Bulk Excavation and Basement Car Park Modification MP10_0023 MOD 3

Submission to the Department of Planning 19 December 2011

City of Sydney

19 December 2011

Figure 2 Diagram of stormwater concept from proponents C5 EA which demonstrates the extent of infrastructure now required.

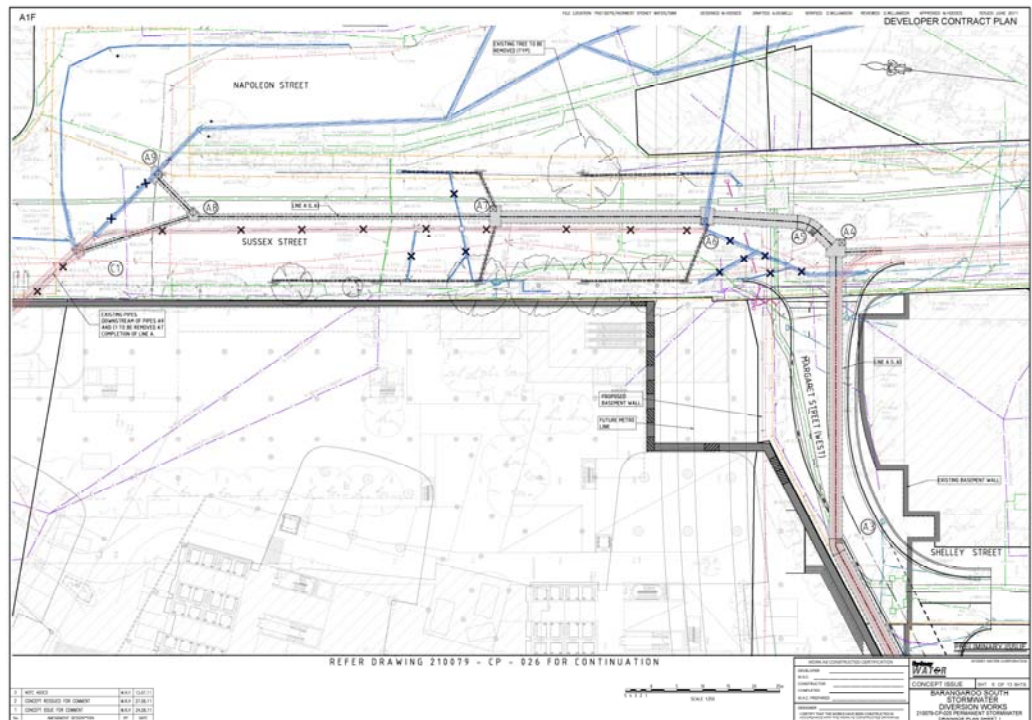
The Project Application Approval includes various conditions that seek to address the road design and flooding issue created solely by the approval.

The City has been liaising with Lend Lease in an attempt to address the requirements of these conditions. The City's latest response to Lend Lease forms Attachment 1. As can be seen from the letter, the solutions are not simple; however the City is committed to affording the resources required to the project to ensure a satisfactory outcome. It is considered that this time and effort being afforded to what will be a poor solution could be saved with a simpler (and more cost effective) redesign of the basement and its RLs, with changes that are far less extensive than the ones proposed by the proponent in the subject application.

The height of this structure and the impact upon the surrounding infrastructure is a fundamental issue that requires resolution prior to the modification being considered by the Department of Planning, and in its current form the application can not be approved.

It is also noted that any lifting or lowering of the existing road network 'requires' the removal of street trees to solve a problem created by the proponent, and this is not acceptable.

Figure 3 Diagram of driveway extending to the temporary road parallel to Shelley Lane.

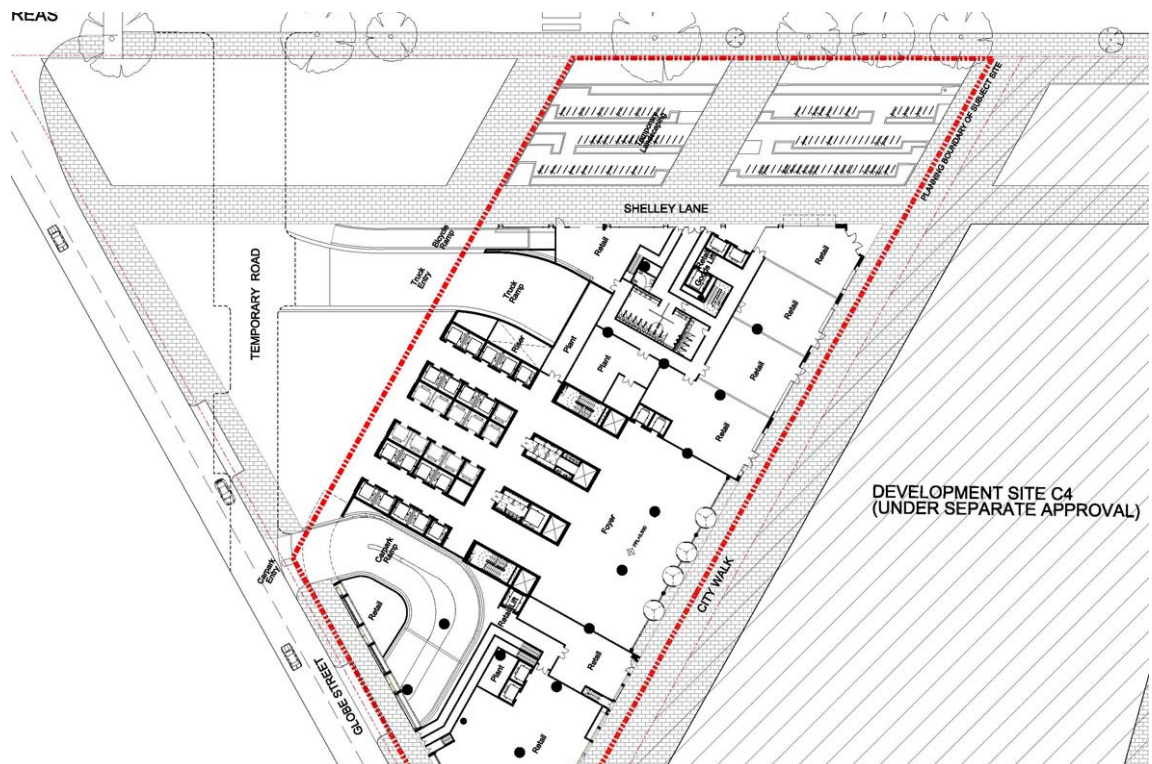
The car park driveway from Hickson Road is described as a secondary driveway. There appears to be no rationale as to why this would be the case or how the proponent would ensure this was the case. The concerns are that the driveway will have a closer proximity to the main road network and therefore more likely to be the one most drivers gravitate towards.

It is difficult to understand the final form of this driveway once the temporary road is removed. Unanswered questions arise such as - Will this driveway have to be extended north and at what level? Will it be parallel to Shelley Lane, deactivating the lane?

This does not indicate future connection once temporary road is removed.

Figure 4 Cross section of the basement showing the approved and modified levels

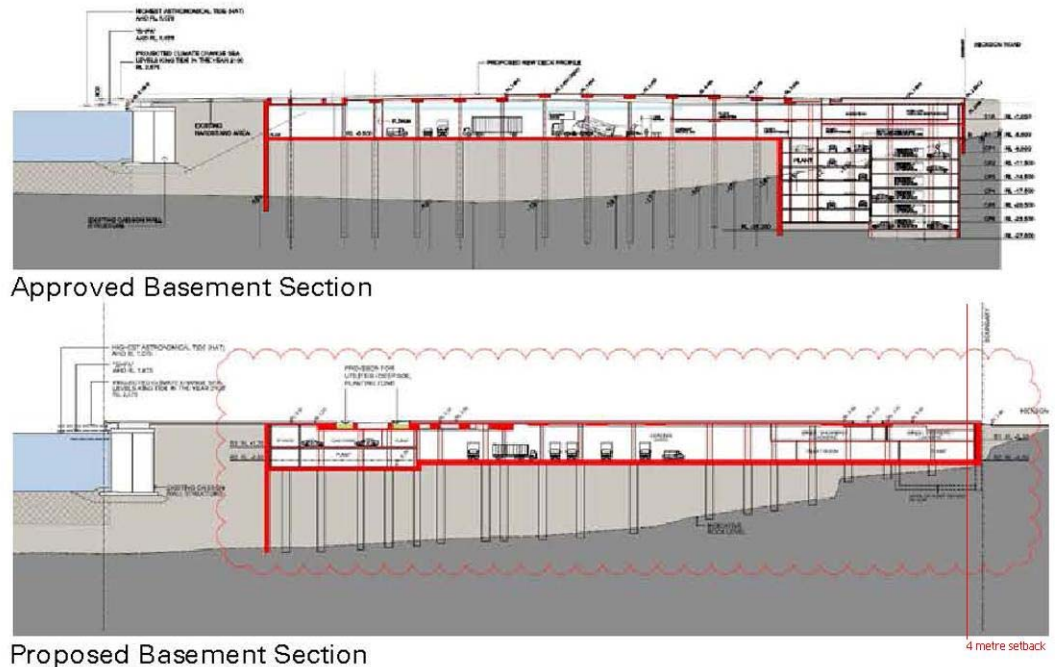
The proposed basement slab extends to the property boundary along the Hickson Road frontage of the site. The top of the basement slab is shown approximately 400mm higher than the existing footway along Hickson Road. This excludes additional build up to the final level of the public domain, expected to be an additional 200mm minimum.

The proposed location and level (+400mm) of the basement slab in relation to the existing Hickson Road will restrict building / entry setbacks, at grade soft landscaping at the street edge, possible footway widening or similar pedestrian friendly design treatments for the ground level building and landscape design along this street frontage.

It is suggested that the current basement design does not allow for the pedestrian friendly tree lined boulevard that was envisaged for Hickson Road in the approved Concept Master Plan – Governing Principles for Public Domain.

It is suggested a basement setback of 4m, a set down or reduction in the level of the top of slab is required to allow flexibility in providing accessible access and a pedestrian friendly design outcome for Hickson Road as a boulevard given the uncertainty of the future treatment of Hickson Road and the location of the light railway.

Figure 5 Diagram demonstrates how a 4 metre set back can be achieved. It is noted that this will impact on plant areas only.

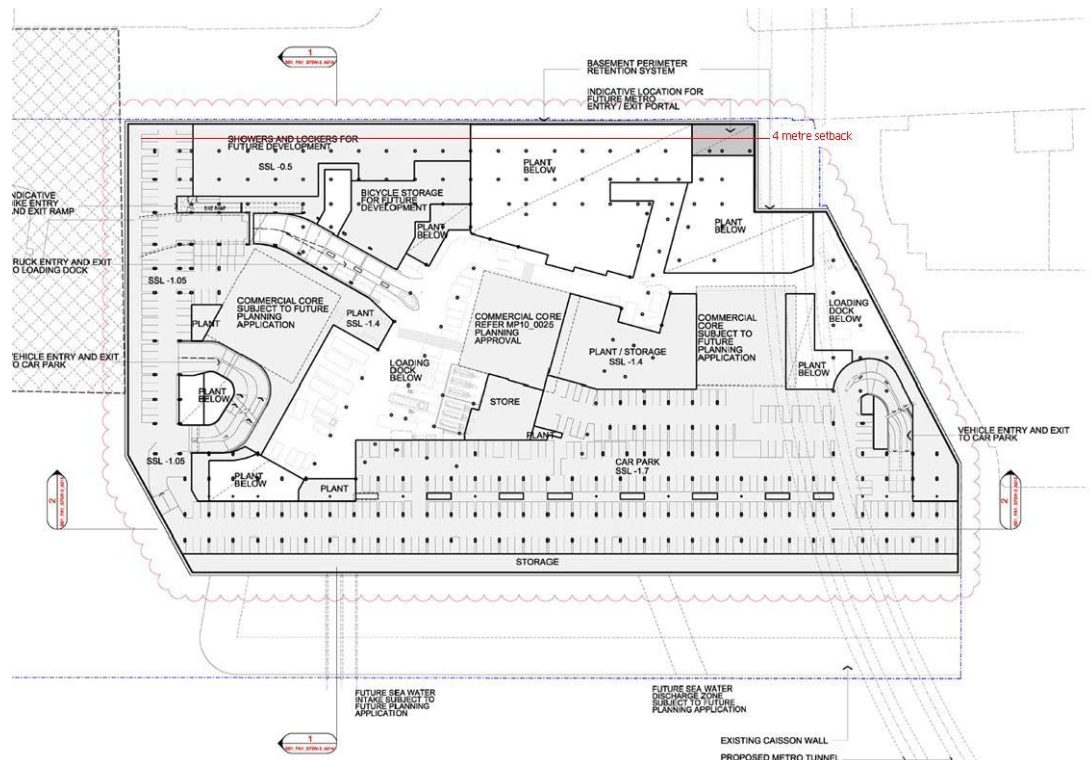
It is noted from discussions about the OFP that current options for drainage in the road reserve include, among the various options, one scenario for an extensive drainage system to be built along the western side of Hickson Road, adding pressure to the Applicant's ability to deliver a quality public domain along Hickson Road.

Although such a proposal would not limit provision of access to the podium, it may impact on the ability to provide soft landscaping at the street edge as noted above.

The constraints posed by the need to accommodate various infrastructure for the wider development of Barangaroo, along with the Applicants proposal to build the basement up to the site boundary limit the ability and tests the commitment to deliver an acceptable streetscape along Hickson Road.

The Applicant should consider a 4m setback or other alternatives to provide flexible opportunities for an improved design outcome along Hickson Road
